**Z-35
(2016)**

CONCEPT PLAN FOR
EBENEZER CHASE
 LAND LOT 304 & 345, 16TH DISTRICT, 2ND SECTION
 COBB COUNTY, GEORGIA

PETITION NO: Z-35

ZONING COMMENTS:

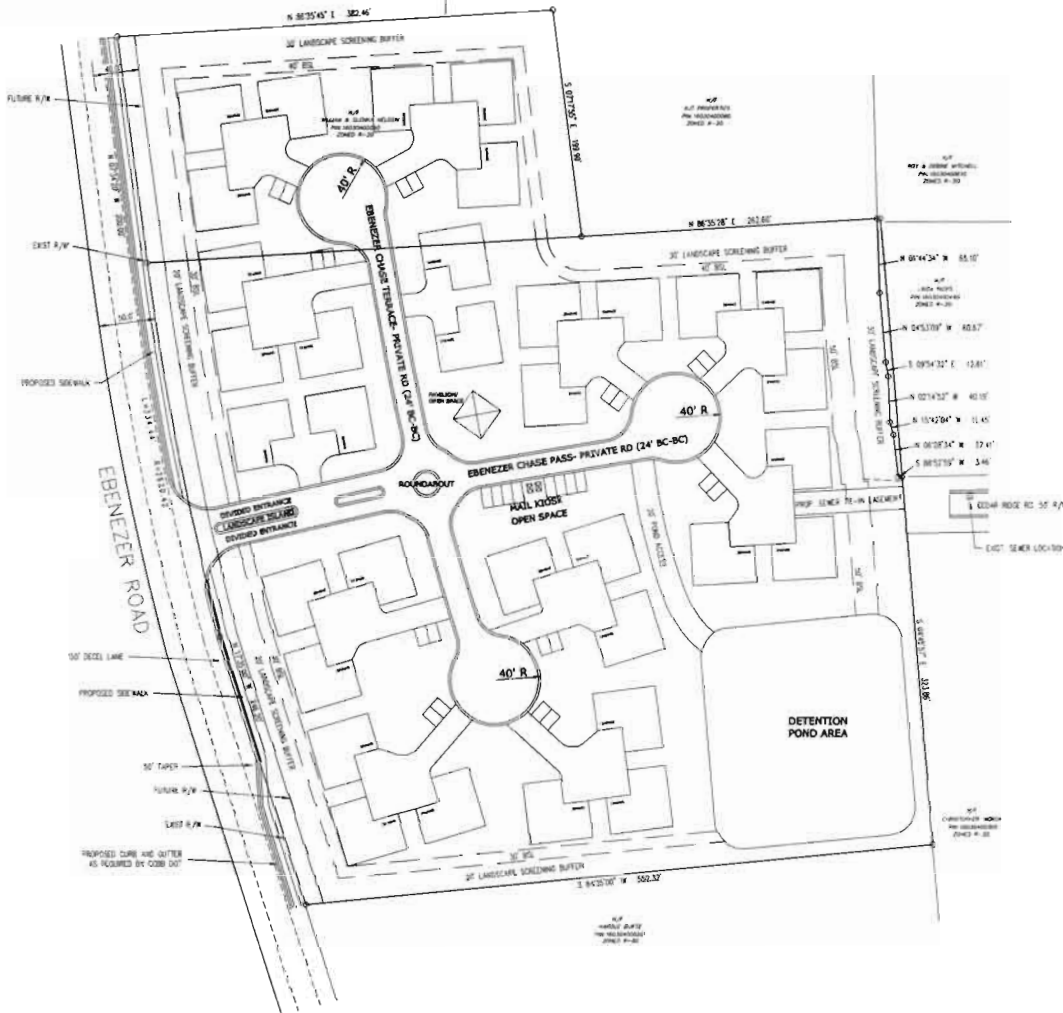
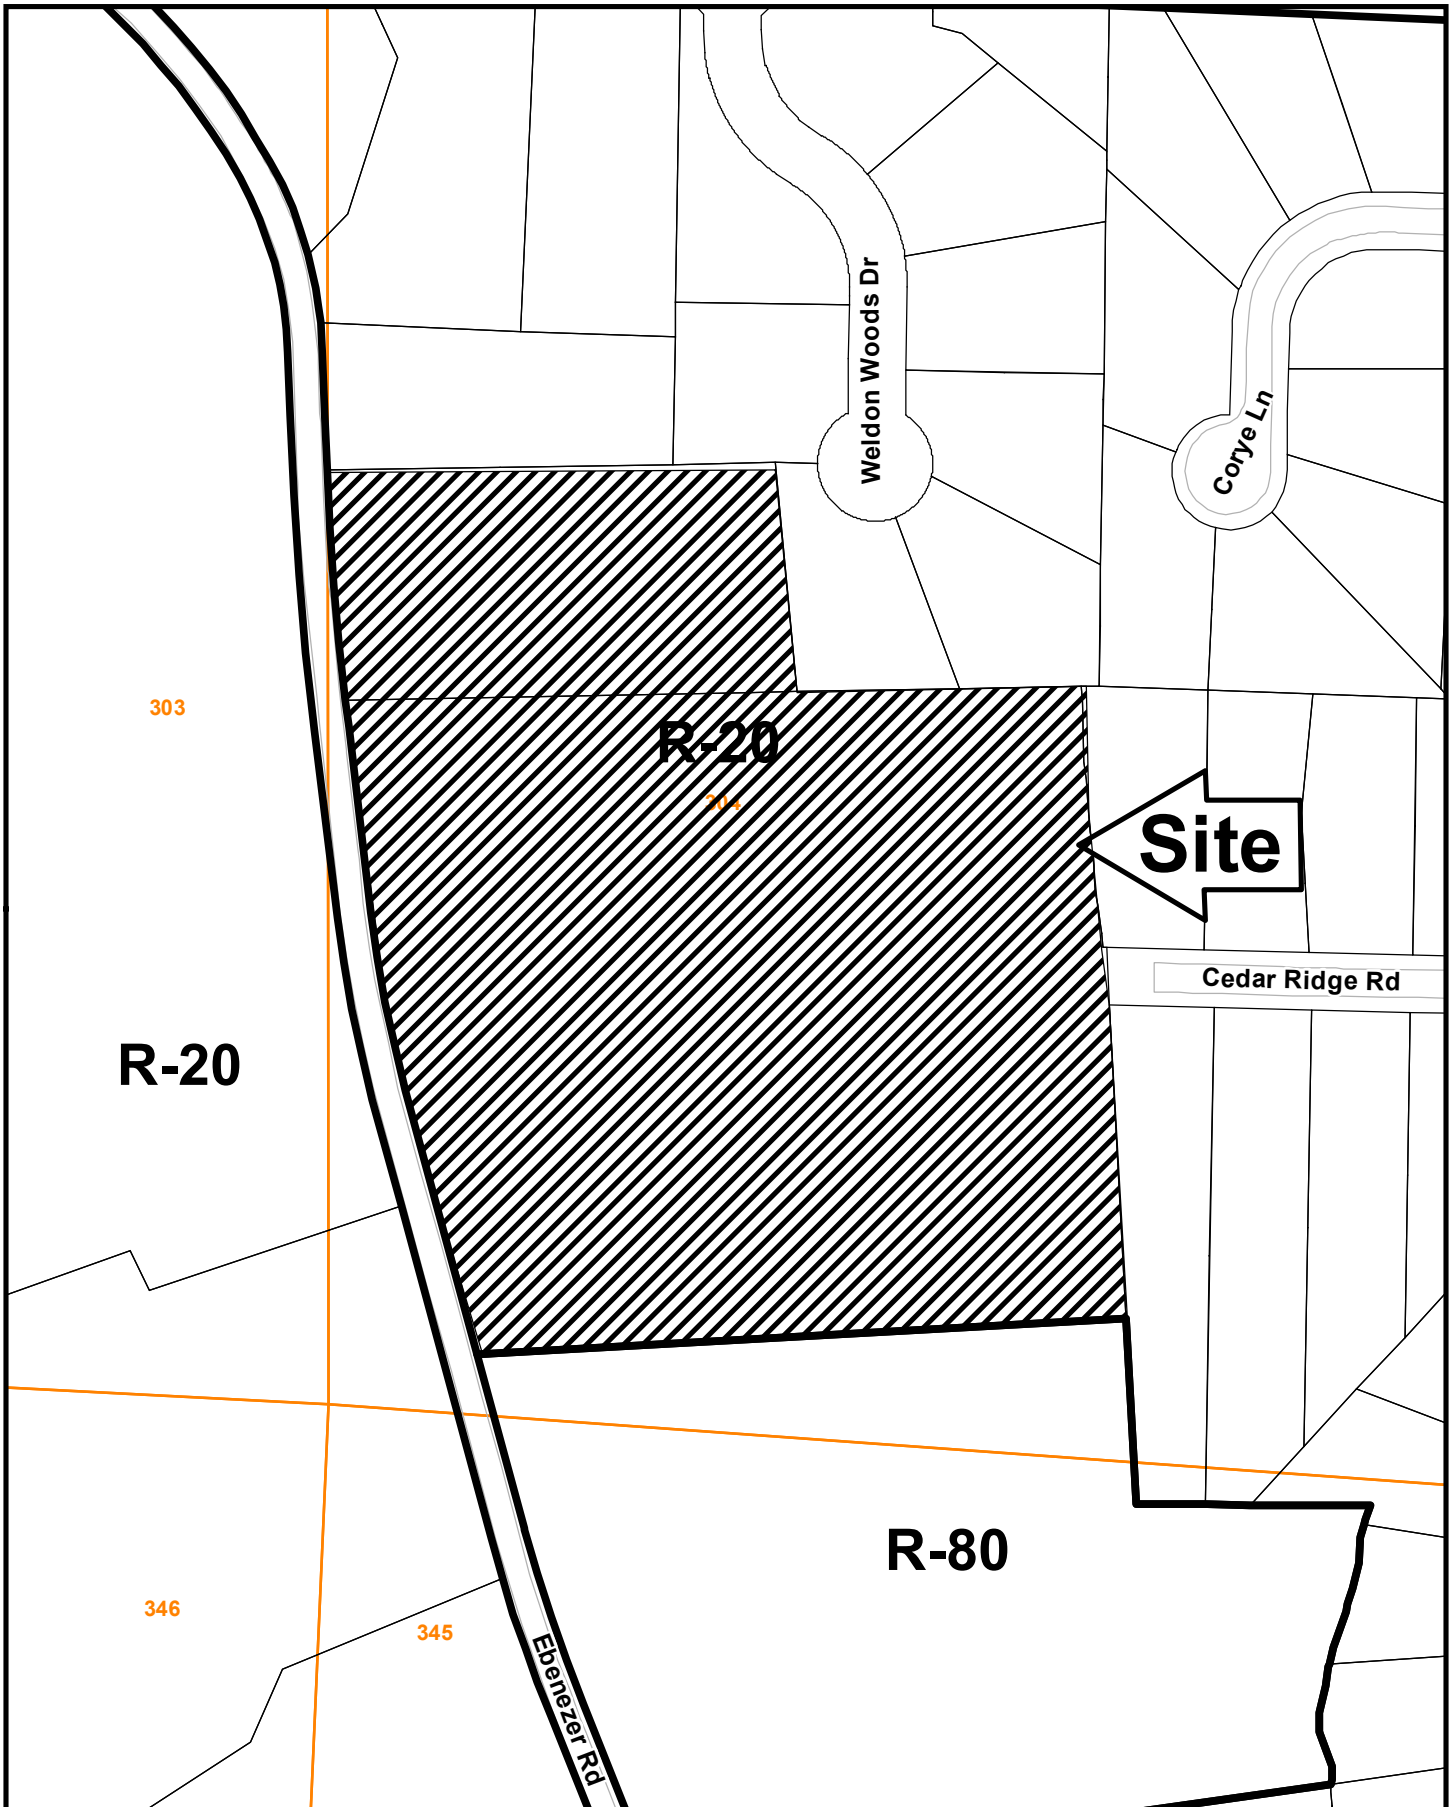
- No Stormwater controls shown _____
- Copy of survey is not current – Additional comments may be forthcoming when current site conditions are exposed.
- No site improvements showing on exhibit.

Revised Comments based on Site Plan received 5/18/2016

1. This site is located to the west of Ebenezer Road between its intersections with Blackwell and May Breeze Roads. It abuts Princeton Manor Subdivision to the north and North Ridge (aka Heritage Farms) Subdivision to the east and south. The site is primarily pasture with small wooded areas along the fence rows and the northern and southern boundaries. Average slopes on the site range from 5 to 15%. The majority of the site drains to the east into and through the North Ridge Subdivision via an existing channel platted as a drainage easement. A very small portion of the northwest corner of the site (1.3 ac) drains across Ebenezer Road to the Phillips Farm property to the west.

2. Development of this project will result in an increase in impervious coverage, storm runoff and non-point source pollution compared to build-out under the current single-family zoning categories. To mitigate, the First Flush Water Quality Best Management Practice Requirements must be elevated to the 1.5-inch rainfall event and each larger storm discharge controlled not to exceed the allowable discharge of the next lower, more frequent storm event (ie. 5-year storm event released at 2-year rate; 10-year event at 5-year rate; etc. to 100-year event at 50-year rate).

3. All current site runoff bypass into 1443 Cedar Ridge Road must be directed to the proposed stormwater management facility.
